231 Seasons Road

Site Plan Application -Tree
Clearing Authorization and
Preliminary Site Plan Review

Hudson Planning Commission	SITE PLAN REVIEW
Case No. 2021-804	August 9, 2021

Re: **Western Reserve Hospital Office Building (Tree Clearing and SWPPP Only)**
Engineering Review - Viewpoint #21-804

Fig. 1 Limits of Disturbance

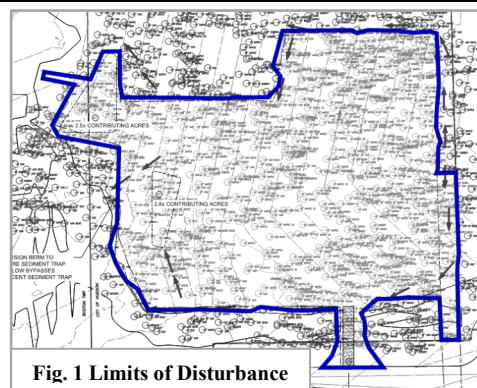
Tree clearing is proposed in the area shown in Figure 1. Staff notes the site activities are concentrated near the Seasons Road frontage with the majority of the site acreage remaining undisturbed. The area within the clearing limits contains mixed maple/ash/oak hardwoods with a general caliper size from 6-12 inches with intermittent mature trees of 20+inches.

- the limits of disturbance at the east property line should be setback 10 feet from the property line to preserve mature maple and oak trees on the adjacent property near the shared boundary.
- The applicant must establish the limits of disturbance in the field prior to commencement of site activities area with silt fencing and/or polypropylene fencing.
- the proposed clearing has been submitted to the Summit Soil and Water Conservation District for review as part of the required Stormwater Pollution Plan (SWPPP) review process.
- The applicant must obtain approval from Boston Township for the proposed limited site activities within the township.

1. Applicant shall submit documentation verifying the proposed tree clearing will be in accordance with Summit Soil and Water Conservation District (SSWCD) and the Army Corp of Engineers.
2. Adjust the tree clearing limits to maintain a 10-foot setback to the east to aid in the preservation of trees on the adjacent property.
3. The comments of Assistant City Engineer, Nate Wonsick regarding tree clearing must be addressed per the August 2, 2021 correspondence.
4. The applicant shall install silt fencing and/or polypropylene fencing to mark and protect the approved clearing limits, which shall be maintained by the applicant. Satisfaction of the above conditions prior to scheduling of a preconstruction meeting with City Officials and no clearing or construction of any kind shall commence prior to the issuance of a Zoning Certificate.
